Advice to the local planning authority

To LPA	Worthing
LPA planning ref no	AWDM/1329/25
Our ref	25-1028
Site address	Car Park Adjacent Sandell House Railway Approach Worthing West Sussex
Proposal description	Erection of a five to seven storey building with 29 self-contained residential units (Use Class C3) including undercroft parking and cycle store linked to listed building
Date on fire statement	17/10/2025
Date consultation received	26/11/2025
Date response sent	17/12/2025

Headline response from HSE
Headline Response from HSE 'Advice to LPA' - Concern

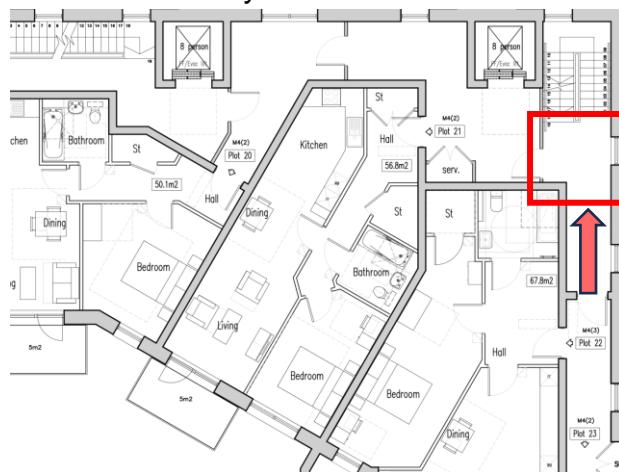
- 1.5. Plan drawings show that for plots 27, 26, 23, 22, 18, 17, 12, 11, 6 and 5, to access the alternate stair the occupiers must pass through an open stair enclosure. Therefore, should this stairway be compromised, occupants of these plots would be trapped, unable to access the alternate stairway.

- 1.7. Additionally, Section 3.33 of ADB v1 states: *"An escape route should not pass through one stair enclosure to reach another. It may pass through a protected lobby (minimum REI 30) of one stair to reach another."*

- 1.8. Design changes to separate the corridor from the staircase will affect the window position (see drawing extract below) and the size of the adjacent flat. . This will affect the layout and appearance of the building and space available for dwellings. It will be for the applicant to demonstrate that the means of escape is capable of being safely and effectively used at all material times, including during firefighting operations.
